Commission Meeting Date: November 29, 2007

#### PLANNING COMMISSION AGENDA ITEM

**AGENDA TITLE:** Continued Public Hearing on Planned Area 2 (Ridgecrest

Commercial Area)

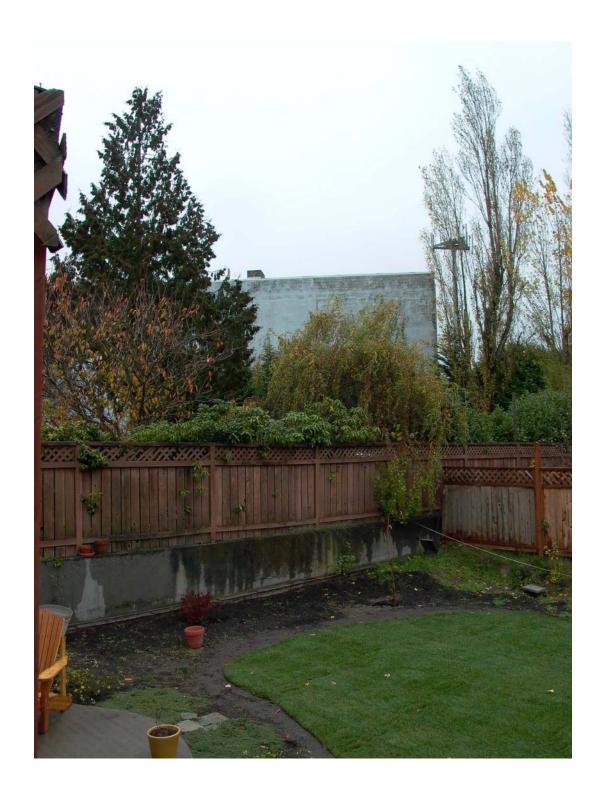
I will not be able to attend the planning commission meeting this evening, but I wanted to share the attached photos taken from my backyard to give the planning staff and any interested commissioners a sense of the current appearance of the site from my family's perspective. As you know from my written submission to the last planning commission meeting, I support the redevelopment of the site into a multi-use facility.

As you can see, the big blank wall dominates the view from our back yard, as well as our neighbors'. With this in mind, I am strongly supportive of a setback from the property line, a tree line or some other type of border to soften the appearance of the new development, and stepping back the upper floors of the new structure on the West side.
